Presentation from Greenpeace

Application to renew the Power
Reactor Operating licence for the
Darlington Nuclear Generating Station

FORESIGHT & SITING:

*The Darlington nuclear station and
unreasonable risks to Toronto and
the environment*

Risk Aggregation for Multi-unit Sites

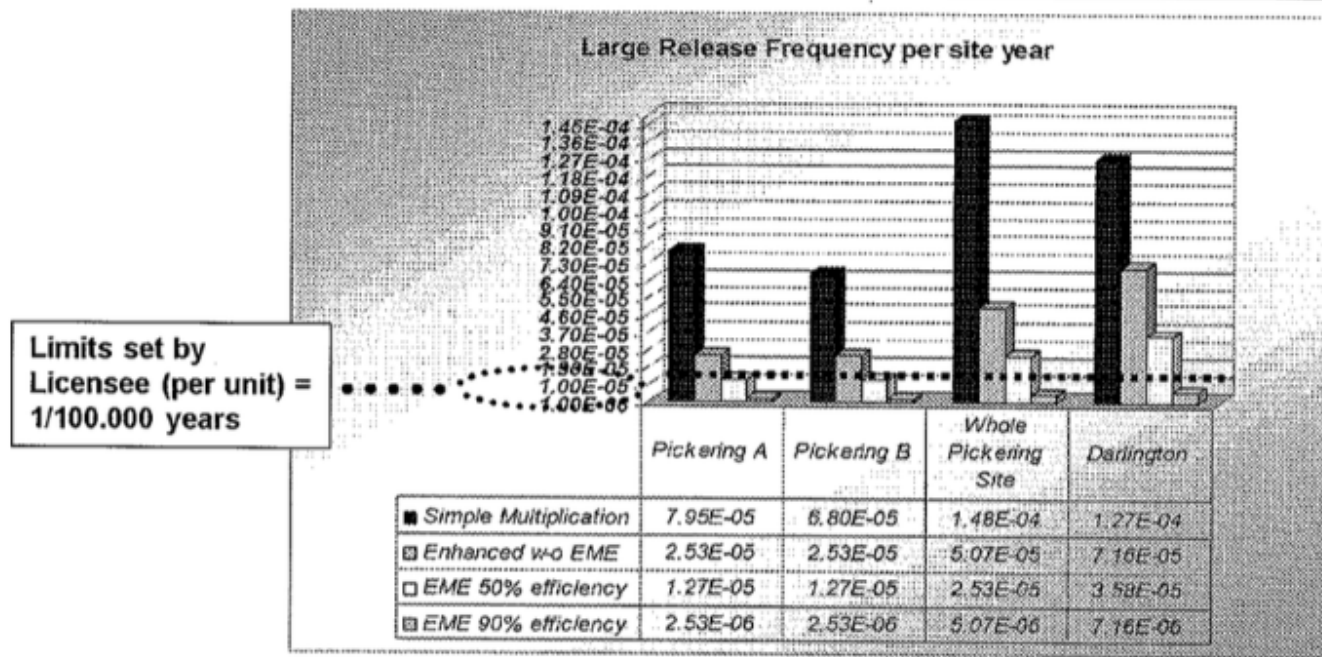
Site Wide Risk: Greenpeace Concern Validated

Site-wide risk is at least 10 times higher than limit for new reactors

CNSC staff internally admit site-wide risk may be “unreasonable” under the Nuclear Safety and Control Act.
